COPPER GATE ADDITION

Re: S/D 98-41 -- One-Step Final Plat of COPPER GATE ADDITION

STAFF REPORT

CASE NUMBER: S/D 98-41 - COPPER GATE ADDITION

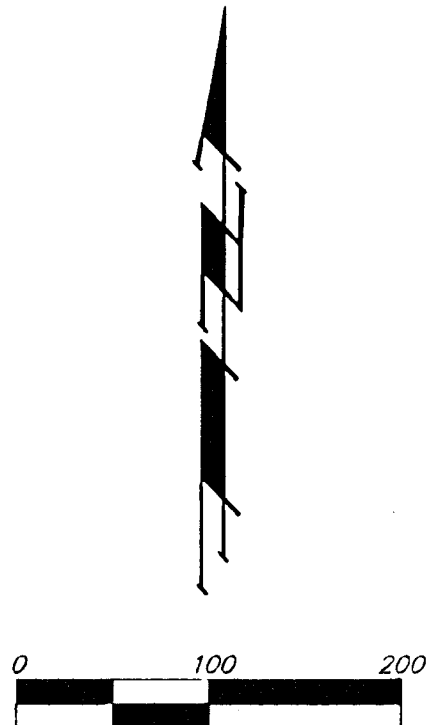
- A. **City Engineering** needs to indicate the need for guarantees or easements. **Guarantees for future sewer and water extension will be needed. Per the CUP, the site cannot be developed until municipal water and sanitary sewer are available.**

- C. **County Engineering** needs to comment on the status of the applicant's drainage plan. **The drainage plan needs to be approved.**
- D. **Traffic Engineering** needs to comment on the acceptability of the access controls. In regards to the southern tract, the plat denotes three openings along 135th St. West - a joint opening between lots 1 and 2, one opening for lot 1, and one opening for lot 3 in accordance with the CUP. Also for the southern tract, the plat denotes two openings along 13th St. North, both located within lot 1 and complete access control along lot 3; whereas the CUP permitted one opening for lots 1 and 3. A CUP adjustment will be needed if this revision is approved. **Regarding the southern tract, Traffic Engineering requires 175 feet of complete access control along the eastern boundary of Lot 3. The three permitted openings along 135th St. must be separated by a minimum of 200 feet. Along 13th St. North, two joint openings along the northern tract (between Lots 1 and 4, and between lots 4 and 2) will line up north and south with openings along the southern tract.**

In regards to the northern tract, the plat denotes three openings along 135th St. West - two openings for lot 4, and a joint access between lots 2 and 3, in accordance with the CUP. Also for the northern tract, the plat denotes two openings along 13th St. North for Lot 4,

with complete access control along lots 1 and 2; whereas the CUP required both of these openings to be joint accesses. Cross-lot access agreements and a CUP adjustment will be needed if this revision is approved.

- F. In regards to street improvements, the CUP required guarantees for 135th Street West and 13th Street North for improvement to three lanes from major openings to the intersection and two lanes beyond along the frontage. The CUP also required guarantees for 135th St. West and 13th St. North for the installation of acceleration and deceleration lanes.

- G. Per the CUP, a cross-lot circulation agreement will be needed to insure vehicular circulation between all lots.
- H. A CUP Certificate shall be submitted to MAPD for recording with the Register of Deeds prior to City Council consideration, identifying the approved CUP (referred as DP-231) and its special conditions for development on this property.

- P. The representatives from the utility companies should be prepared to comment on the need for any additional utility easements to be platted on this property. **Southwestern Bell requests additional easements.**

- D. **Regarding the southern tract, Traffic Engineering requires 160 feet of complete access control along the eastern boundary of Lot 3. The three permitted openings along 135th St. must be separated by a minimum of 200 feet. Along 13th St. North, two joint openings along the northern tract will line up north and south with openings along the southern tract. There shall be 175 feet of critical access control on both the north and south sides of 13th Street, from 135th Street West. Critical Access Control should be provided from a point 243 feet west of 135th Street to a point 431 feet west of 135th Street.**

In regards to the northern tract, the plat denotes three openings along 135th St. West - two openings for lot 4, and a joint access between lots 2 and 3, in accordance with the CUP. Cross-lot access agreements and a CUP adjustment will be needed if this revision is approved.
